# PHASE II RENOVATIONS TO THE FORMER BANKS SCHOOL ELDERLY HOUSING CONDOMINIUMS AND PHASE III RENOVATIONS TO THE FORMER BANKS SCHOOL ELDERLY HOUSING CONDOMINIUMS

ADDENDUM NO.5

September 19, 2011

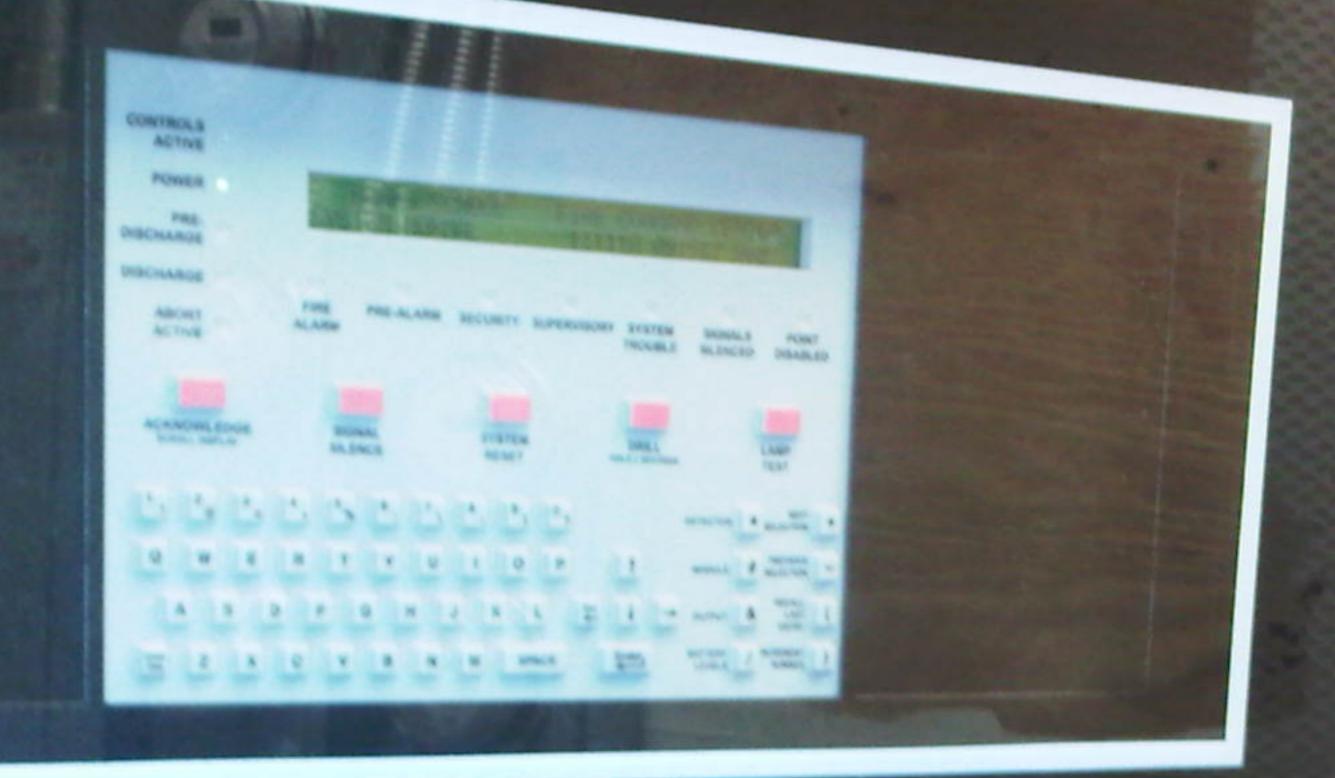
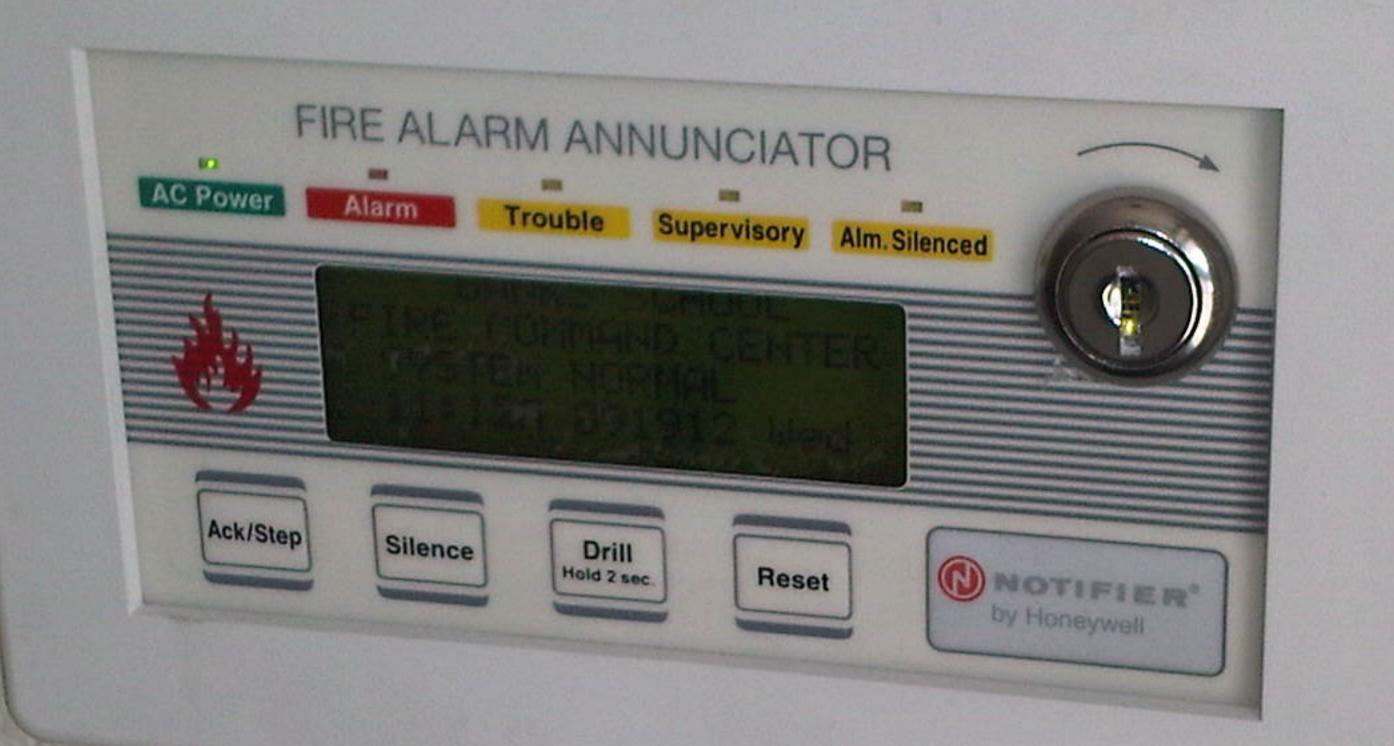
- **Q1**. What is the existing Fire Alarm System in the building? Should the new devices match the existing?
- **A1**. Please see attached Pictures of the existing Panel. The new devise must match and be compatible with the existing system.
